## Planning Commission Draft Motion EIR Certification

*Record No.:* 2015-010013ENV  
*Project Address:* 30 OTIS STREET  
*Zoning:* C-3-G (Downtown – General) Zoning District  
NCT-3 Moderate-Scale Neighborhood Commercial Transit Zoning District  
85/250-R-2 Height and Bulk District  
85-X Height and Bulk District  
Van Ness & Market Downtown Residential Special Use District  
*Block/Lot:* Block 3505; Lots 010, 012, 013, 016, and 018  
*Project Sponsor:* Jessie Stuart, Align Real Estate  
255 California Street, Suite 525  
San Francisco, CA 94111  
*Staff Contact:* Julie Moore – (415) 575-8733  
[julie.moore@sfgov.org](mailto:julie.moore@sfgov.org)

DATE: September 13, 2018  
TO: Members of the Planning Commission and Interested Parties  
FROM: Lisa Gibson, Environmental Review Officer  
Re: **Responses to Comments on Draft Environmental Impact Report for the 30 Otis Street Project, Case No. 2015-010013ENV**

FIGURE RTC-1: HUB PROJECT STATUS

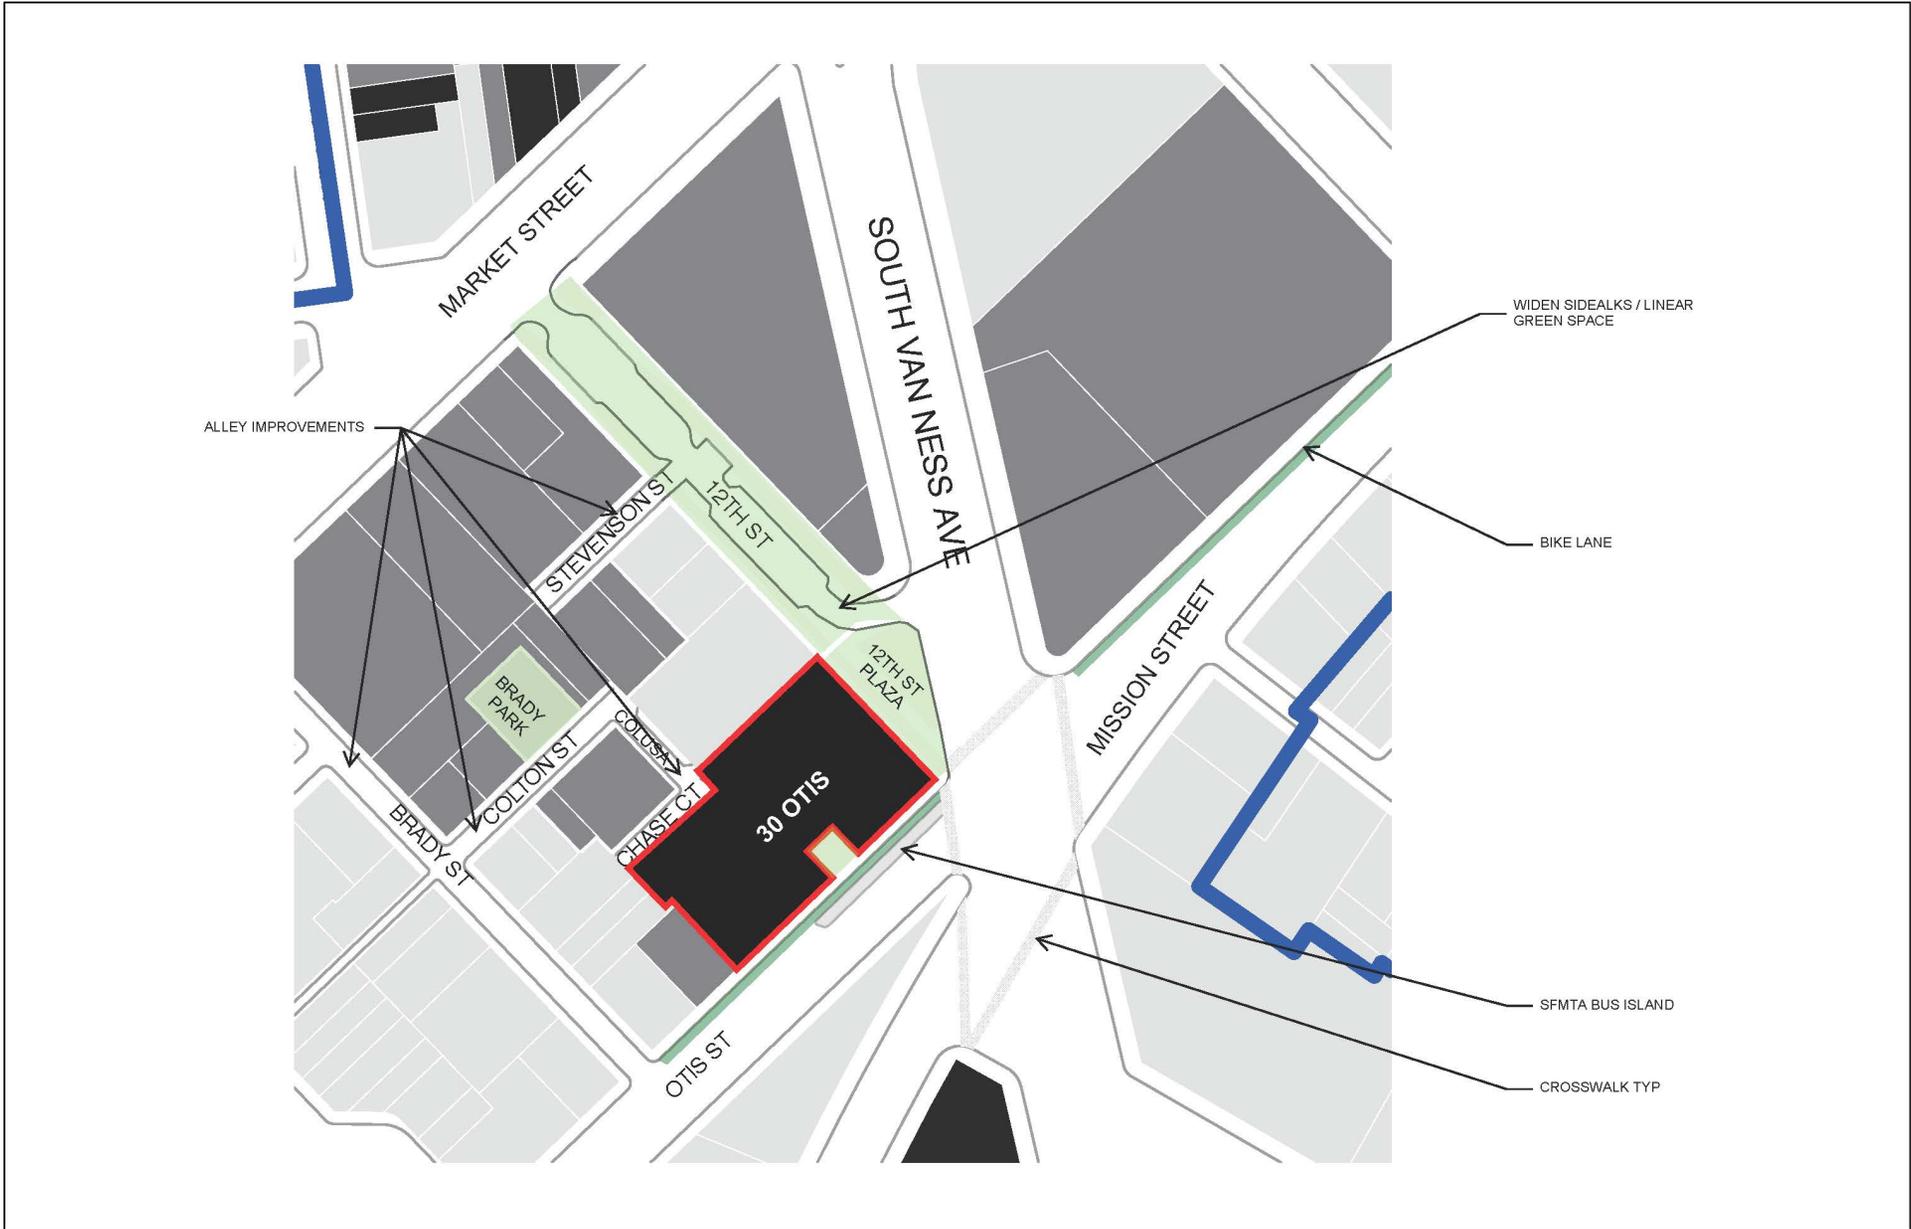
I believe that the EIR as a draft as it's written falls short of giving us a broader overview. One, about the 3D context in which this building will occur. Two, reflecting on the larger principles of the Hub enabled plan pedestrian connections, the open space, light rail etcetera. It has to all work with each other including the simple functioning of the where crosswalks are, where visual relationships and markers are.

And I would suggest that we add a little bit more in that description, so that we when this building -- when the EIR comes forward and ultimately we would be asked to approve the building, the EIR has carefully reflected and described that particular aspect of the project.” (Commissioner Kathrin Moore, San Francisco Planning Commission, Public Hearing Transcript, July 19, 2018, A-CPC1-1, PS-1)

developments, proposed pedestrian connections, open space, and transit improvements. In response to this request, Figure RTC-1, Hub Project Status, below, depicts the cumulative setting along with the Hub Plan boundary, and includes development projects that are consistent with current zoning as well as those that would be reliant upon the proposed Hub Plan rezoning.
